TO:
ATTN:
SUBJECT: De-Air Port Retrofit and Air Removal Procedure

Information Bulletin: Effective Serial Number Range: 3310, 3320, 3420, 3710 and 3720 built prior to Sept 2019

Instructions

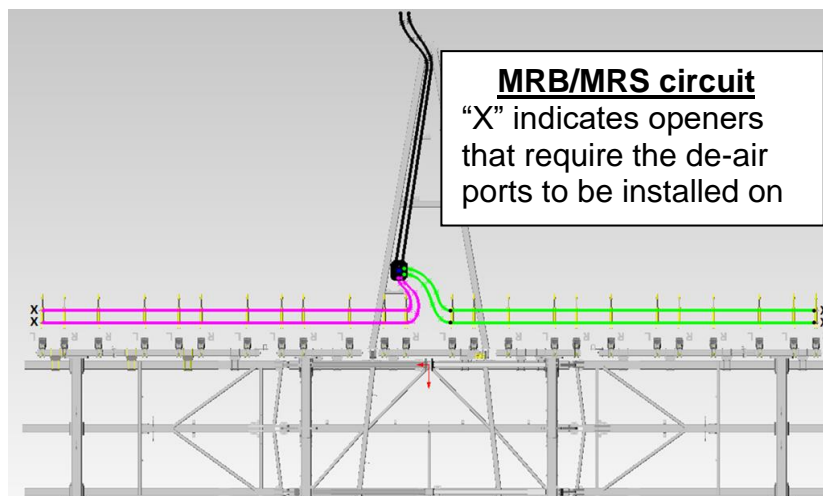
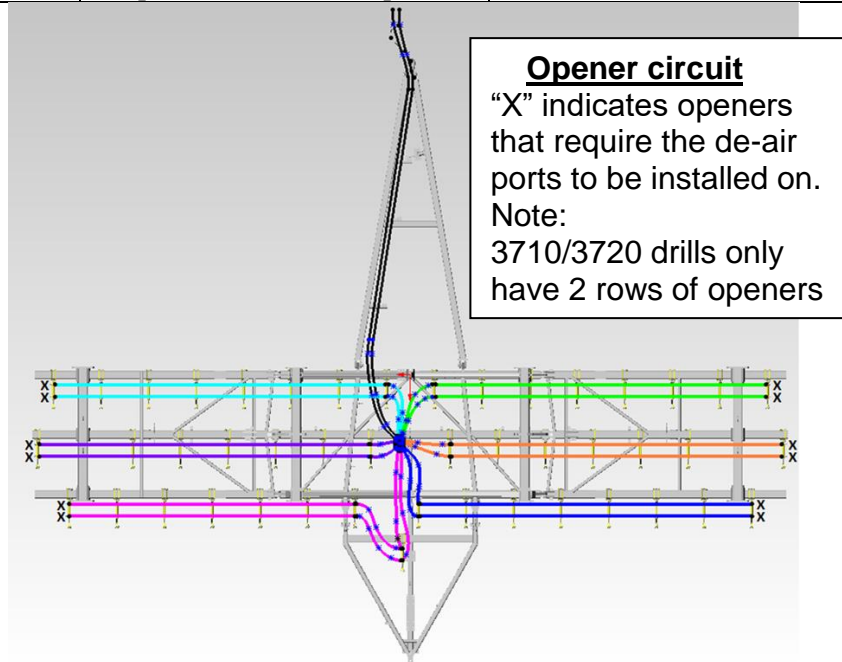
1. In each required location remove the existing elbows/unions and add the tees (3345-29) – make sure to orient the tees so the previous hose routings can be achieved – test ports will either face upwards or towards the outside of the drill.
2. Re-install the hoses and install test port fittings (3346-96) onto the tees
